MEETING AGENDA.....<u>PLANNING BOARD</u> <u>TOWN OF CORTLANDT</u> <u>6:30 TUESDAY EVENING*</u> JULY 9, 2024

PB 2024-1 a. Application of <u>KPB Properties LLC</u> for Site Development Plan approval and a referral from the Town Board of a Petition for a Zoning Text Amendment for a proposed 4-story, 75,000 sq. ft. self-storage facility located at 3 Locust Avenue. Drawings latest revised June 20, 2024.

TO: Town of Cortlandt Planning Board

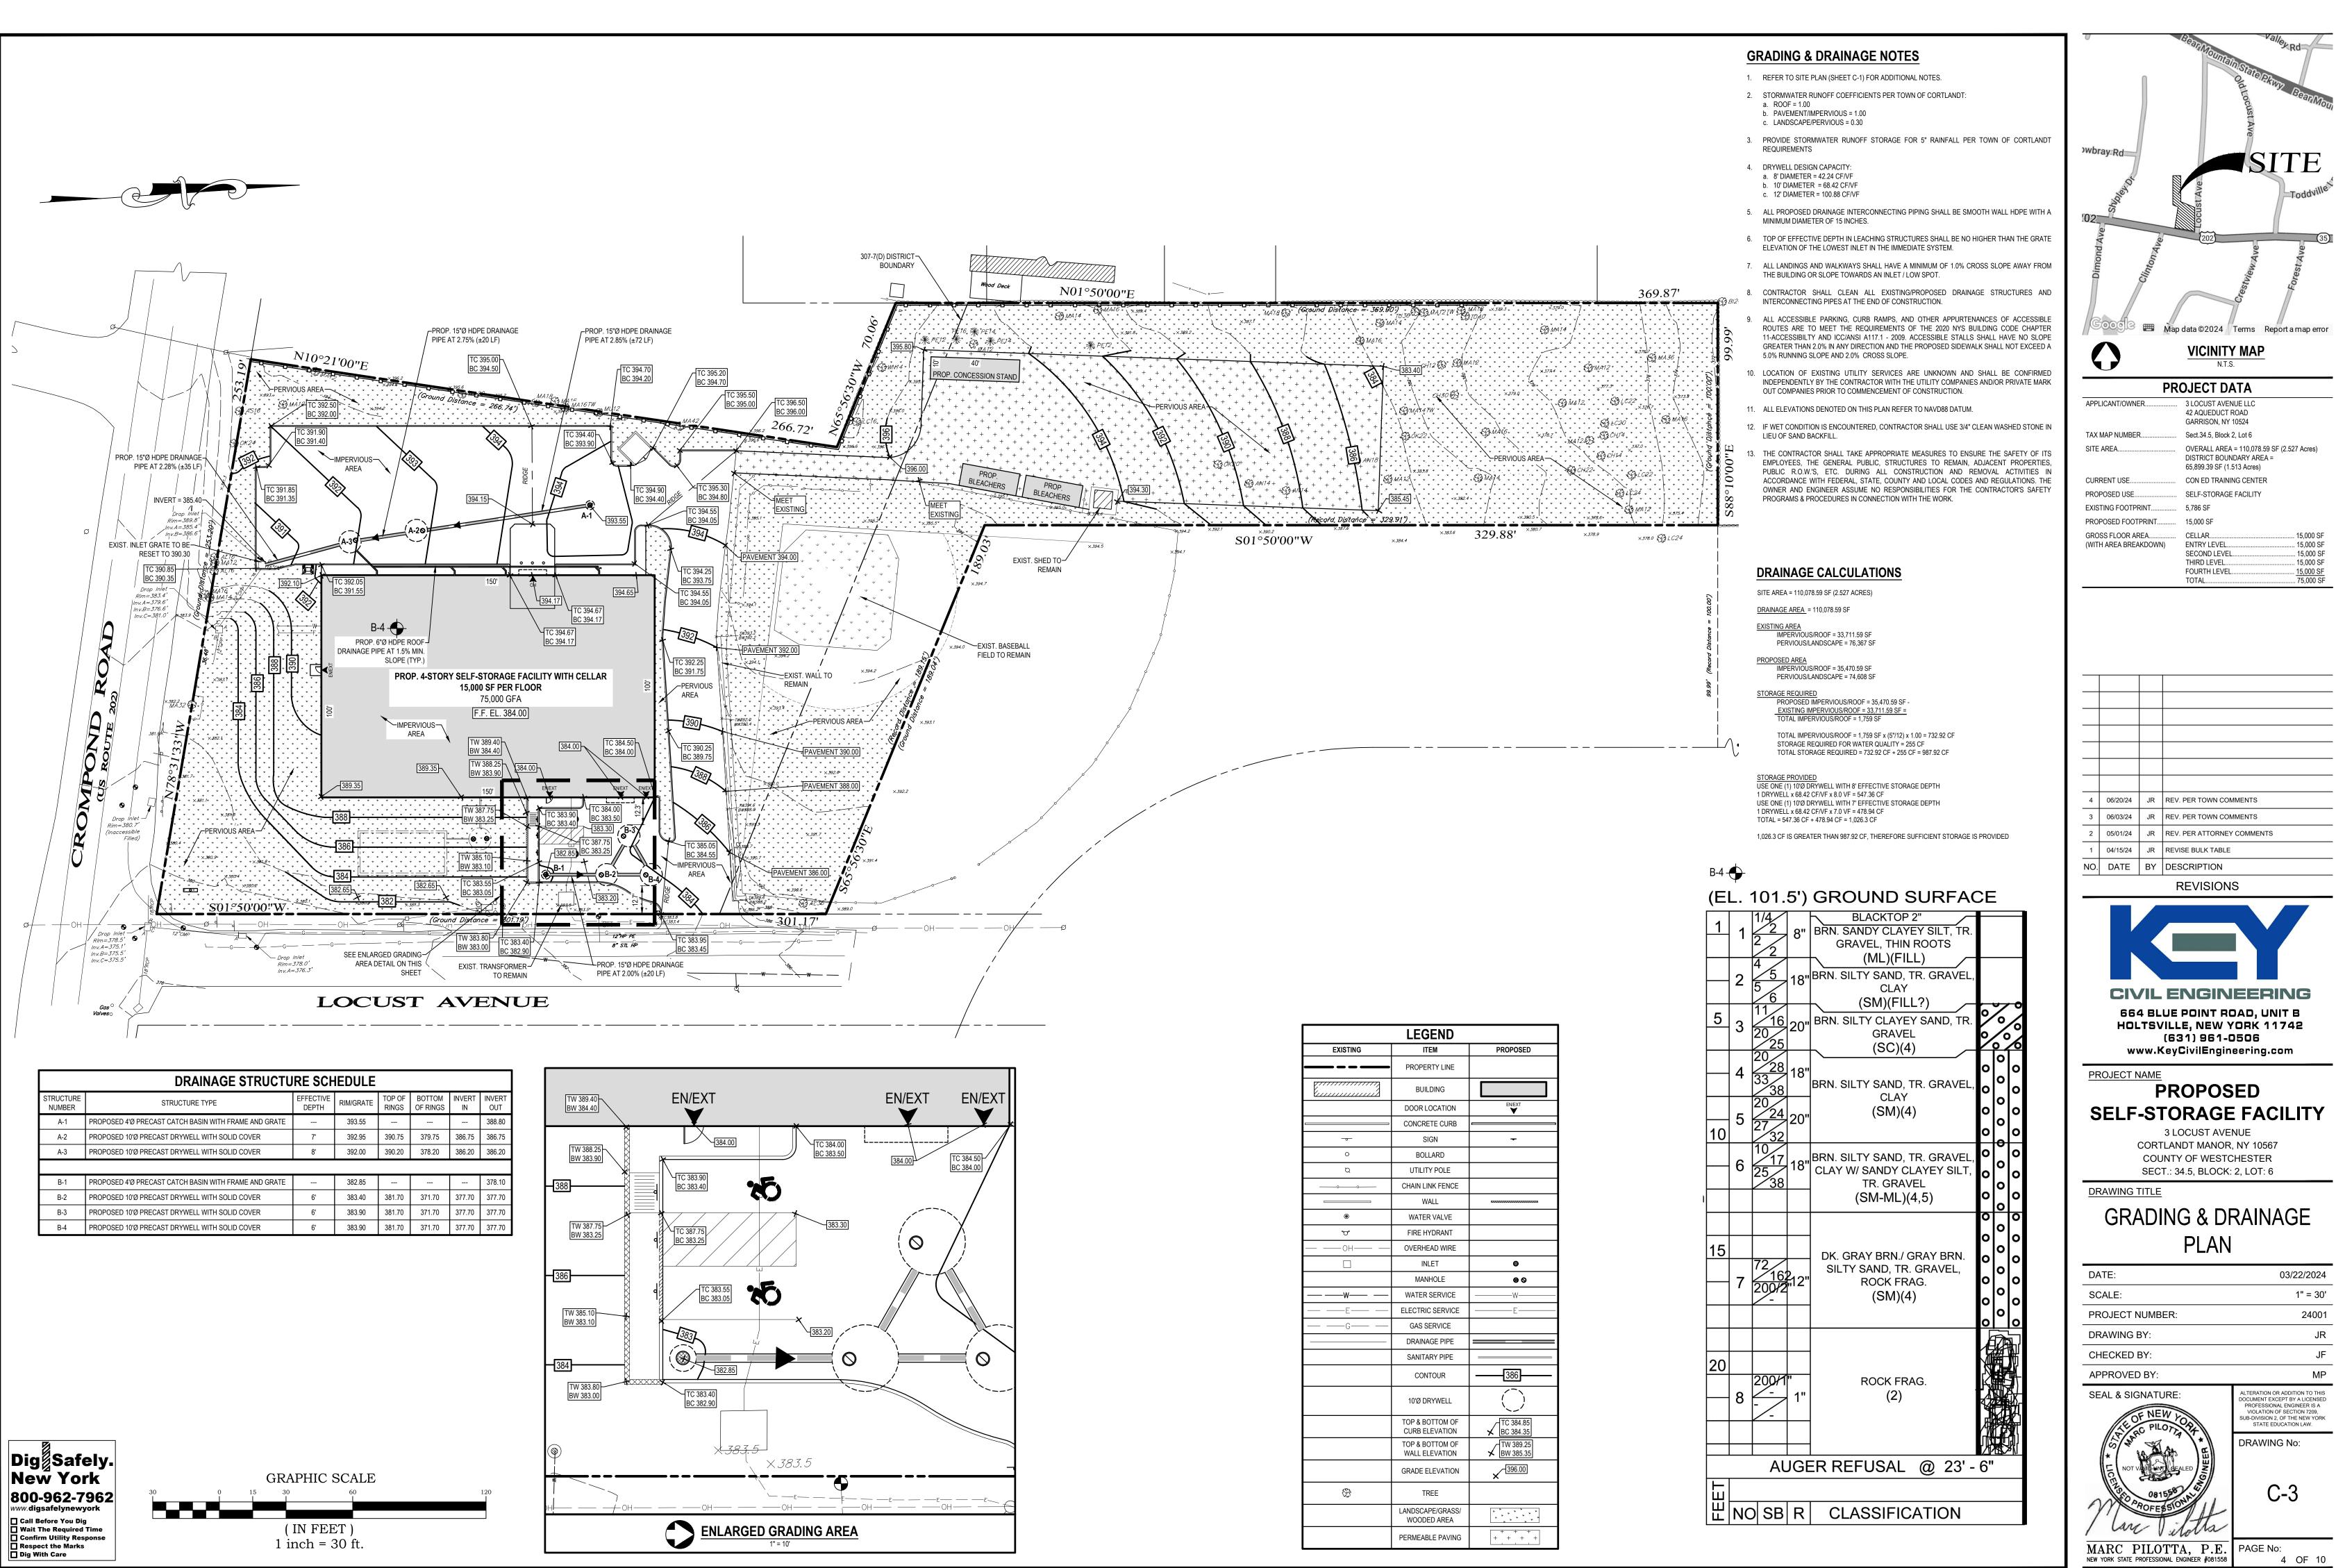
- 12. Sheet C-2 indicate location of either sanitary sewer lateral or septic tank/leaching fi
- 13. Sheet C-2 Site Removal Notes, Note 2 Add the word "Legally" in front of removed from subject premises

- 14. Sheet C-2 Site Removal Notes, Note 14 Add the word "Legally" in front of disposed of in accordance
- 15. Sheet C-3 Grading & Drainage Notes, Note 14 Remove Note in entirety, this drawing is titled as a Grading Plan and thus must bear the correct grading contours for construction

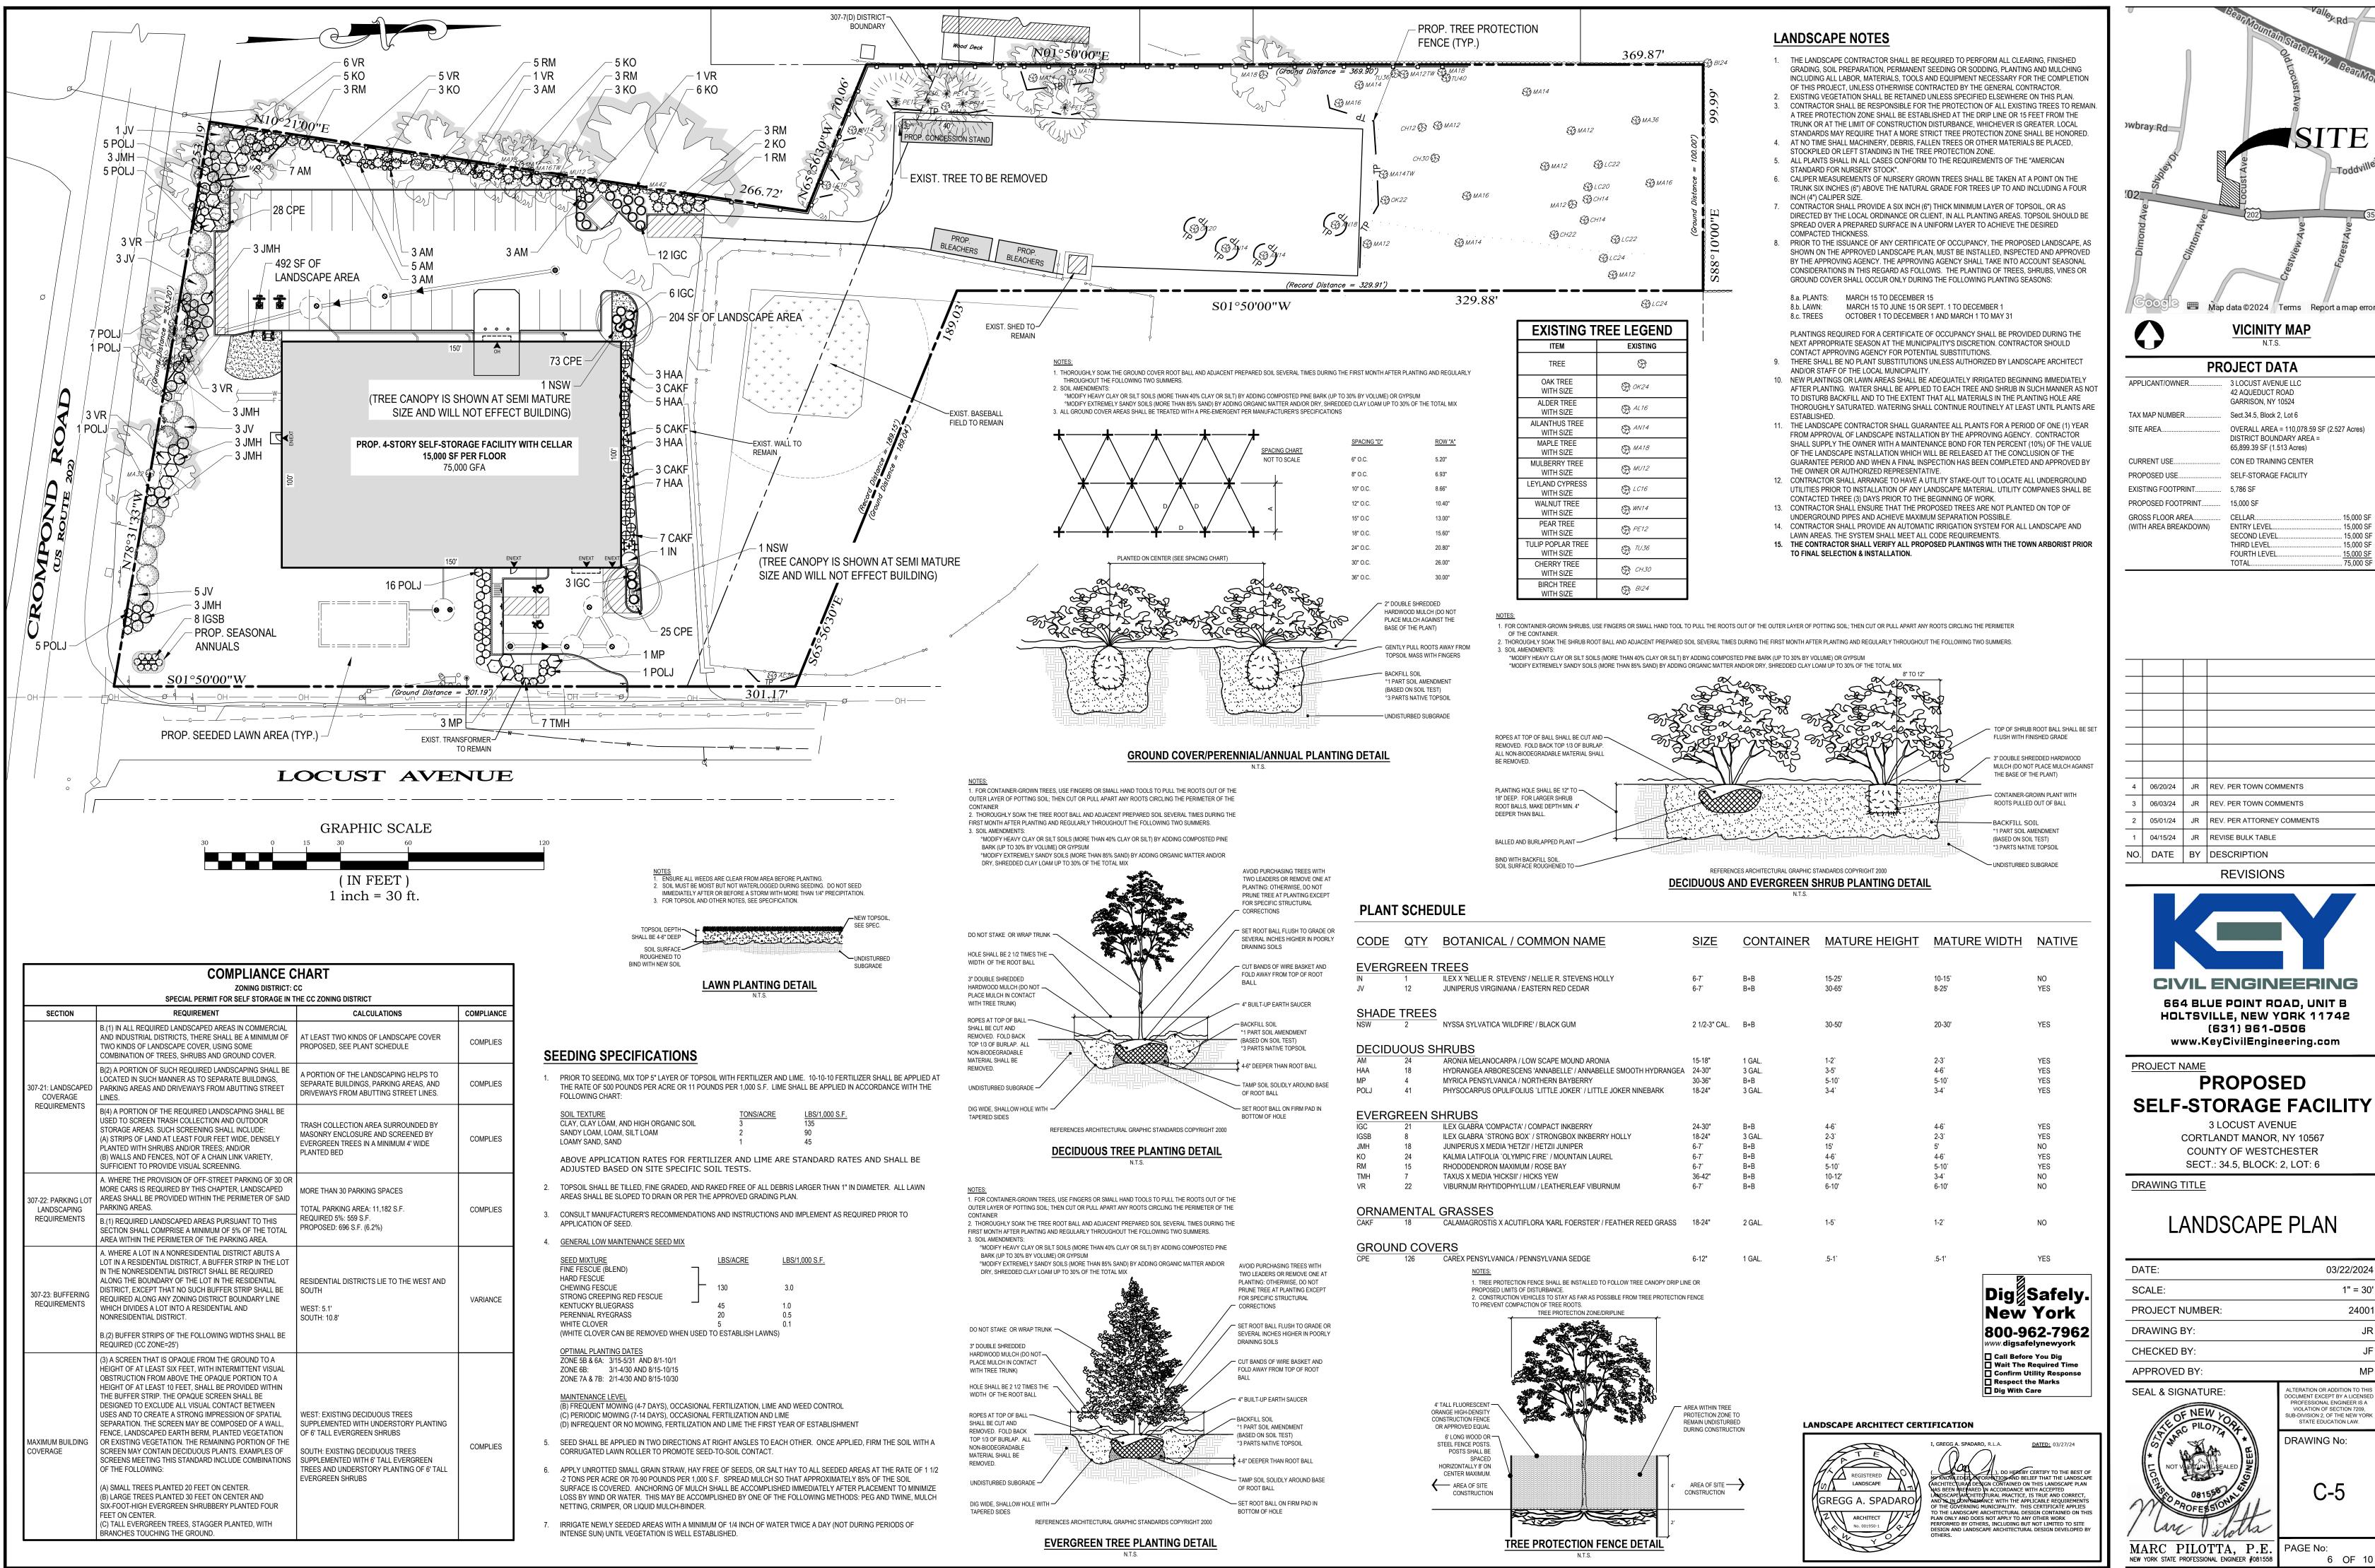
- 16. Sheet C-3 Provide pretreatment for the proposed dry well
- 17. Sheet C-3 The effective depth of the proposed dry well should be taken from the invert of the outlet pipe. Revise the design as necessary.

- 18. Sheet C-3 Confirm with the manufacturer that the porous pavers can be installed at the proposed slopes shown.
- 19. Sheet C-3 Revise the plans to ensure all impervious areas are indicated
